**Presentation on the Jackson Bluff Dam Spillway Project**

**RE: Surface Water Management Application 04-2009-0006 I**  
**Jackson Bluff Dam Spillway Modification – Gadsden County**

Re: City of Tallahassee – Corn Hydroelectric Generating Facility  
Spillway Modification Project – Application 04-2009-0006 I  
Request for Information dated October 19, 2009

RE: City of Tallahassee – Corn Hydro Spillway Modification  
Application 20-0296182-001-DF - Request for Additional Information – Item #3

City of Tallahassee  
C. H. Corn Hydro Facility  
Attachment 3 - Hydrographs for Inflow = 68,000 cfs  
Emergency Spillway Breach

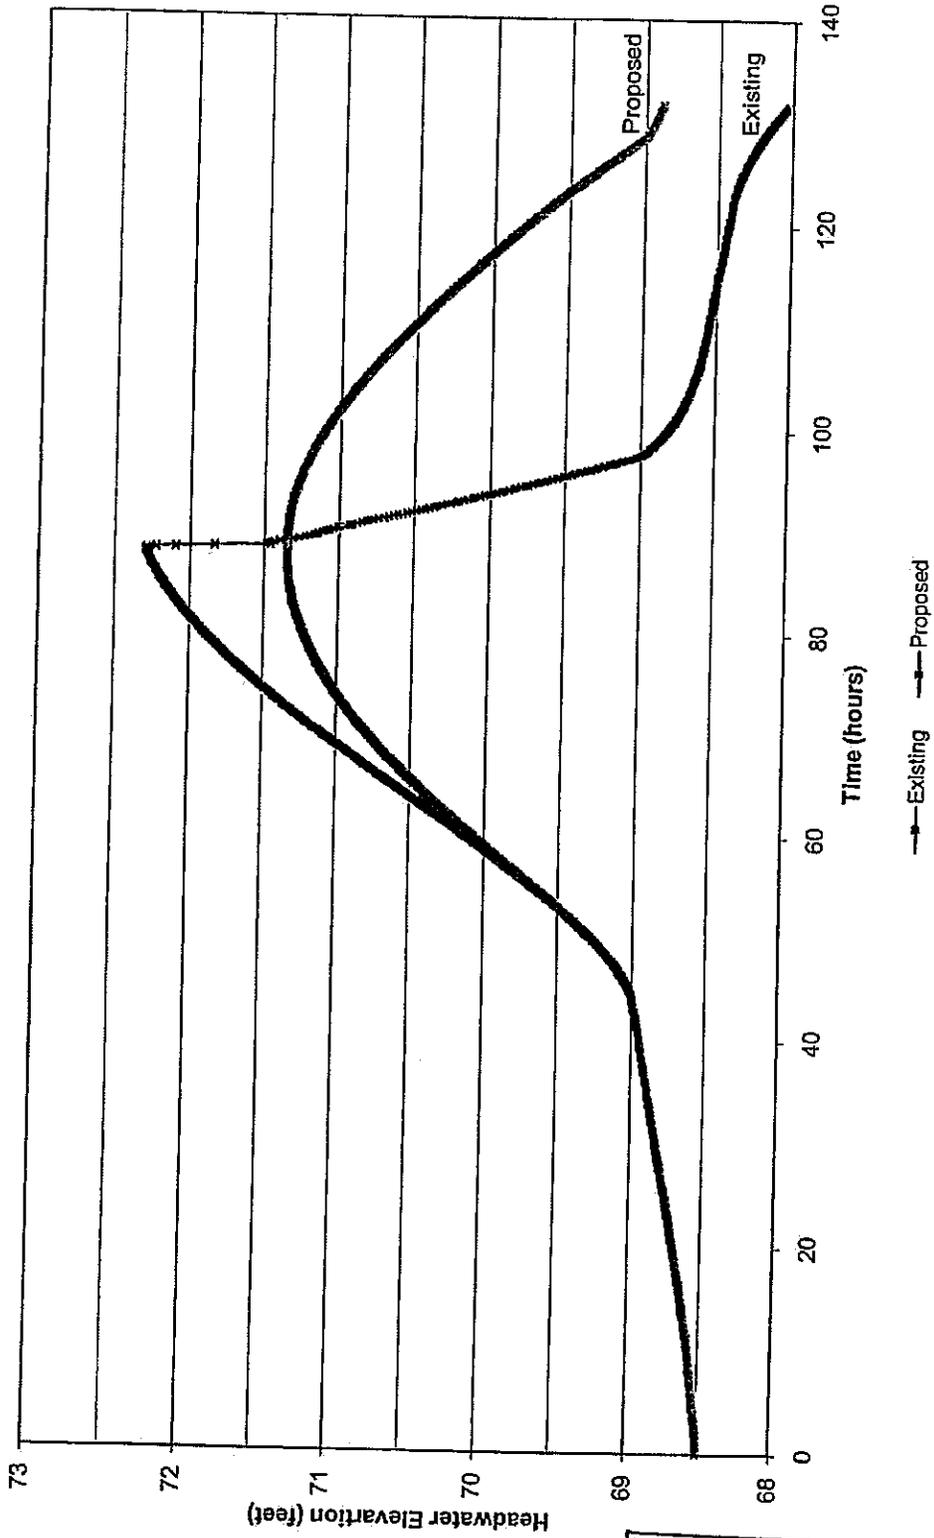
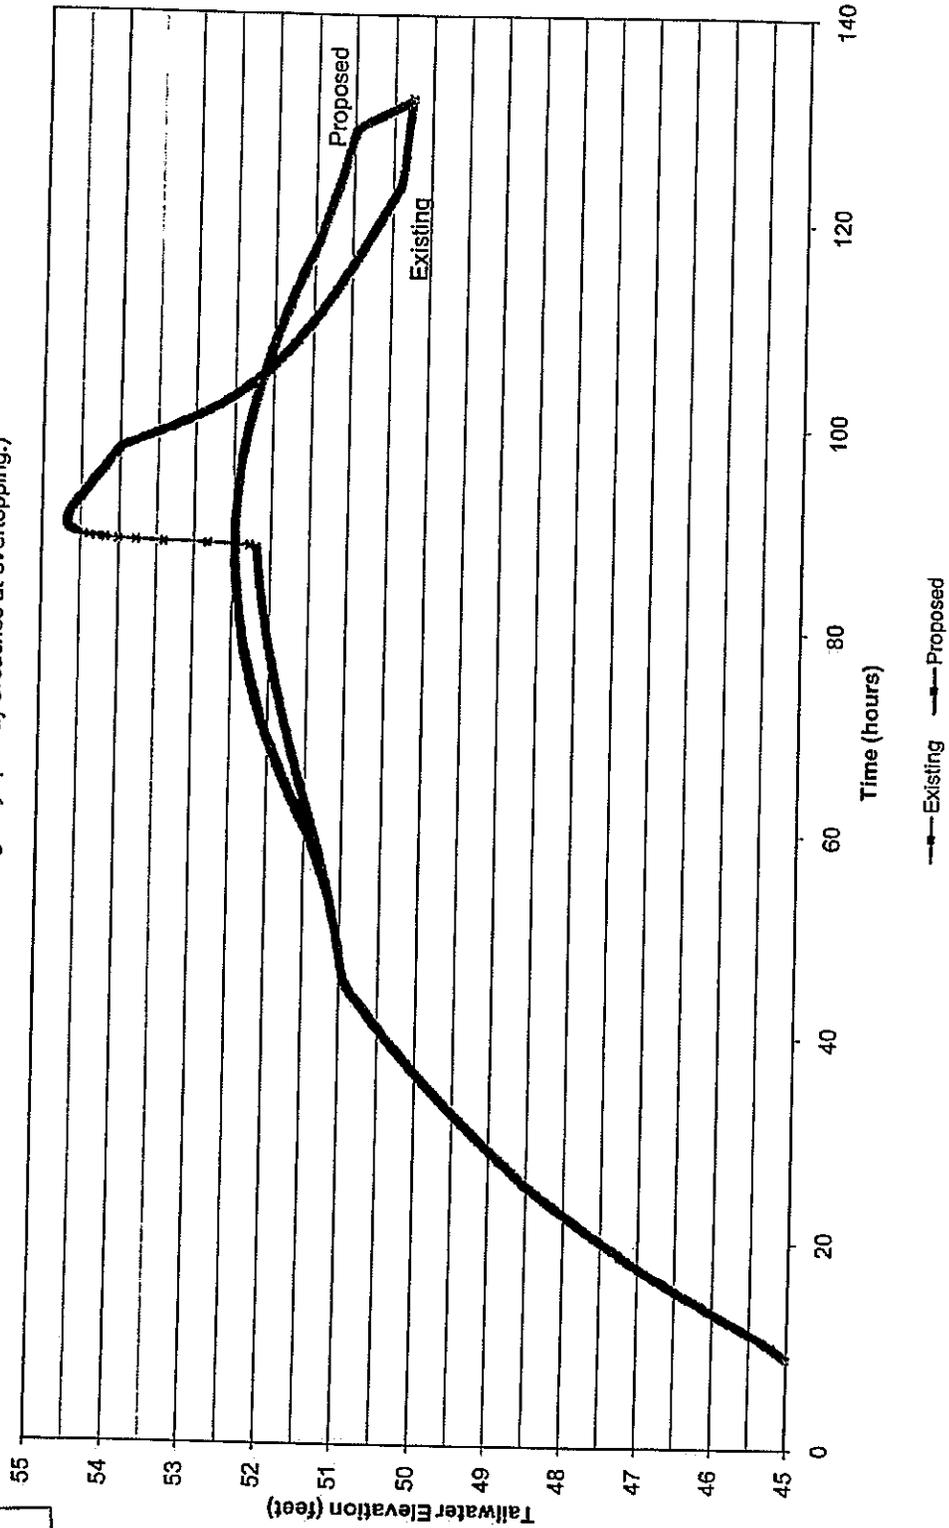
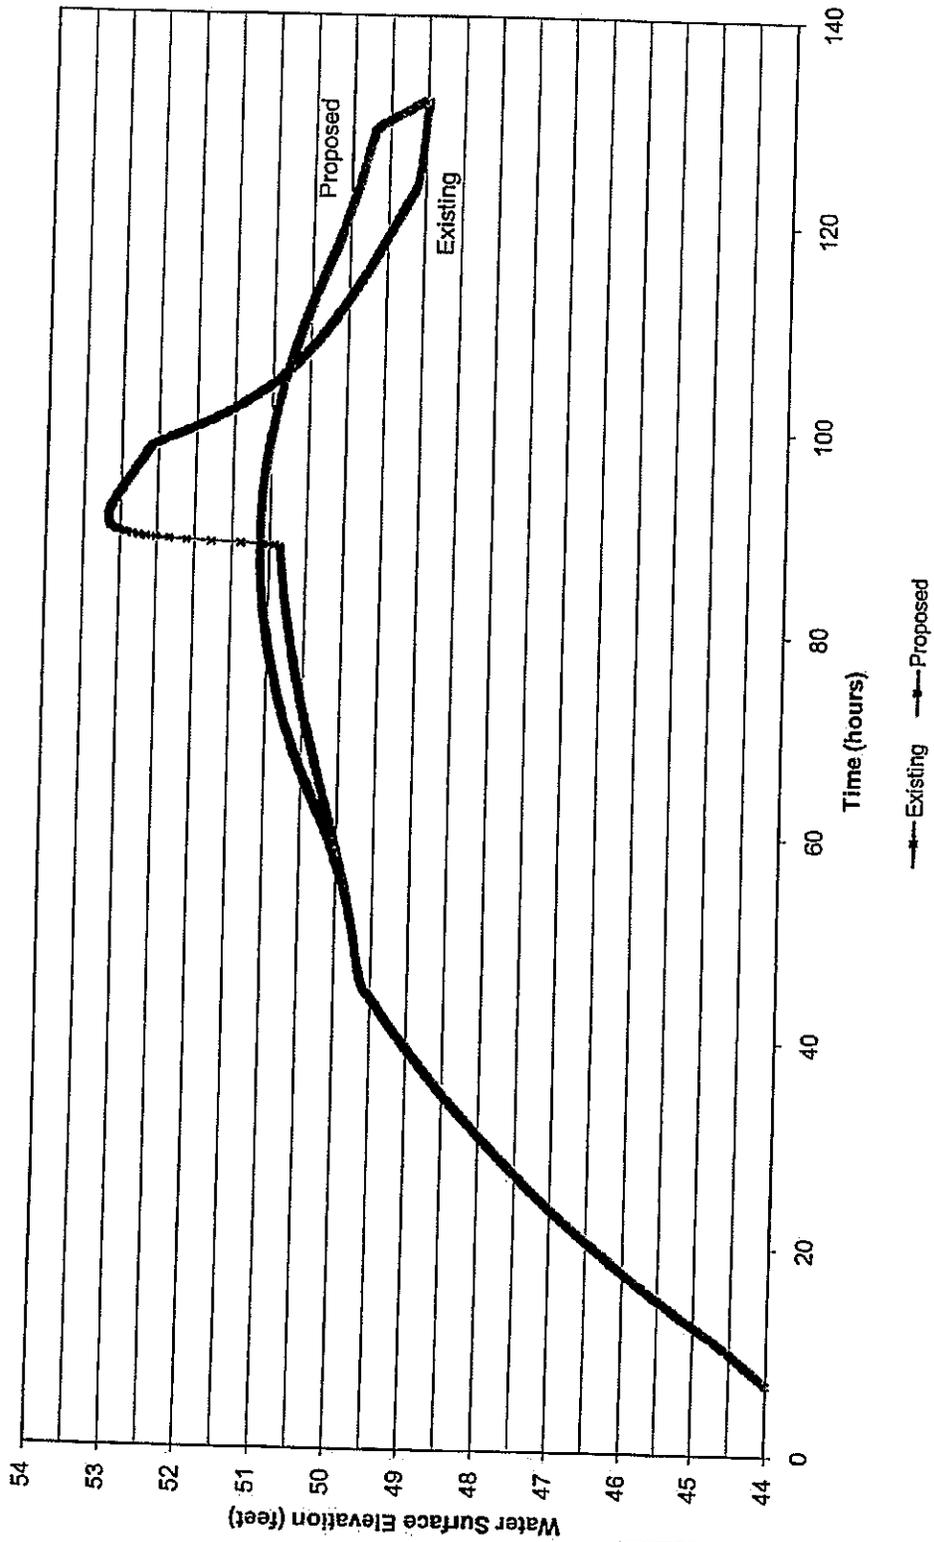
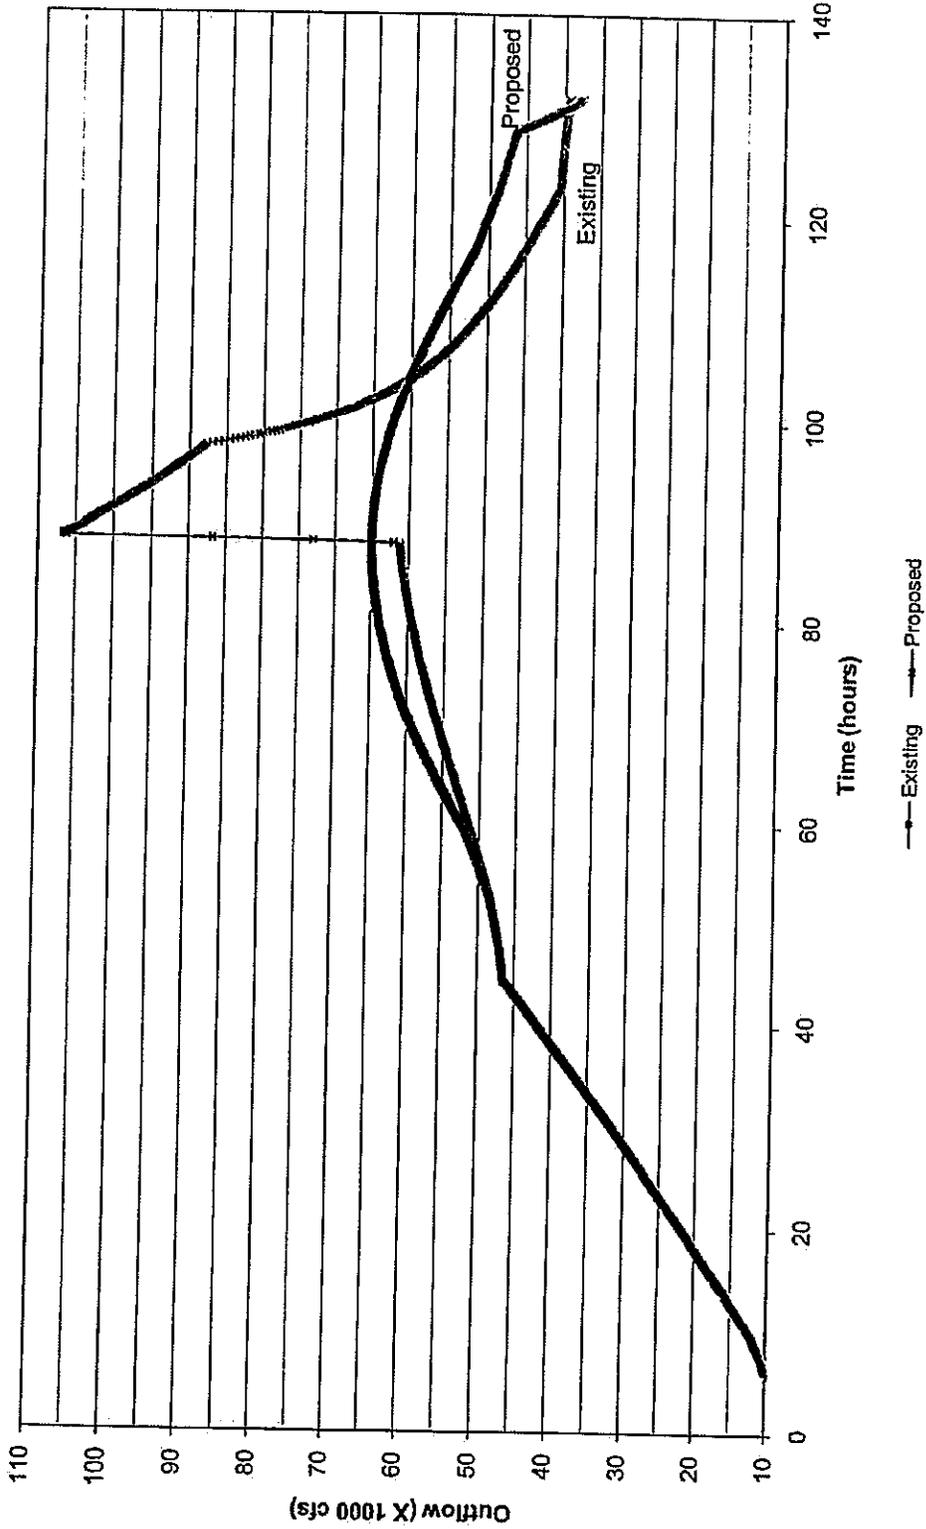
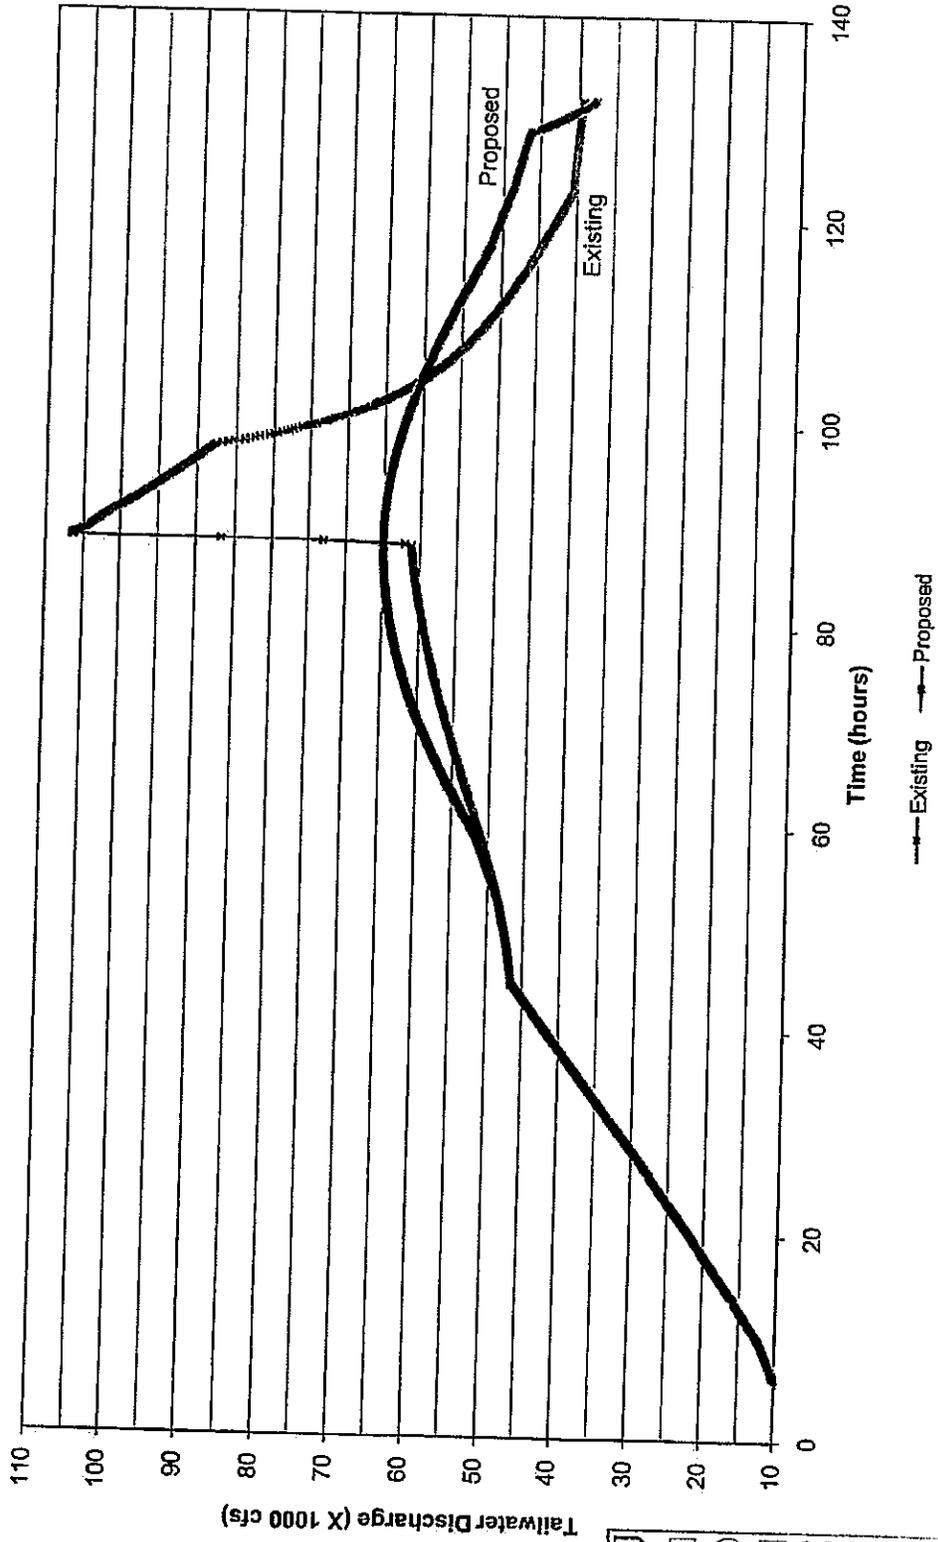
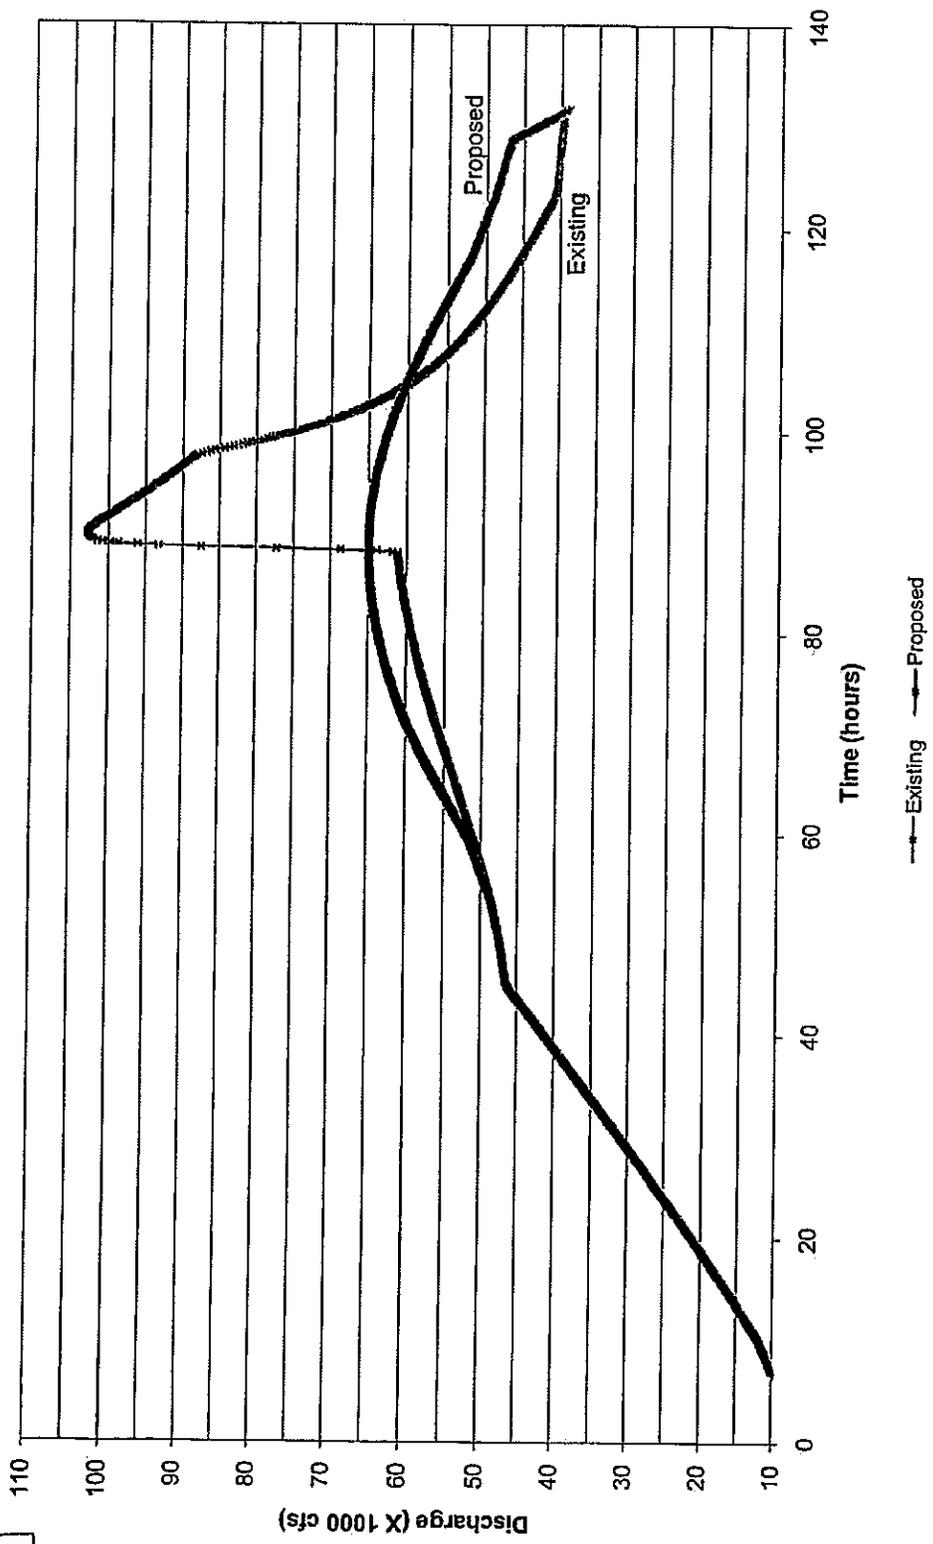
As you know, we recently received an objection letter concerning your project's proposed lowering of the spillway. Please provide a letter clearly stating and justifying that the lowering of the existing invert of the spillway by 2.5 feet will not increase the potential for flood damage to the houses downstream of the dam.

The emergency spillway is overtopped at an inflow of 68,000 cfs. Attachment 3 shows the water surface elevation and flow versus time under a flood peaking at 68,000 cfs, assuming the emergency spillway fails at the time of overtopping. The breach depth was assumed to be 26.3 feet (similar to that for the 1957 dam failure) and the average breach width was assumed to be 131 feet (5 times breach depth). The graphs in Attachment 3 show that the downstream river level for the existing condition will be approximately 2 feet higher than that for the proposed design, if a failure would occur at the emergency spillway. The flow for the existing condition will be over 40,000 cfs higher than that for the proposed condition.
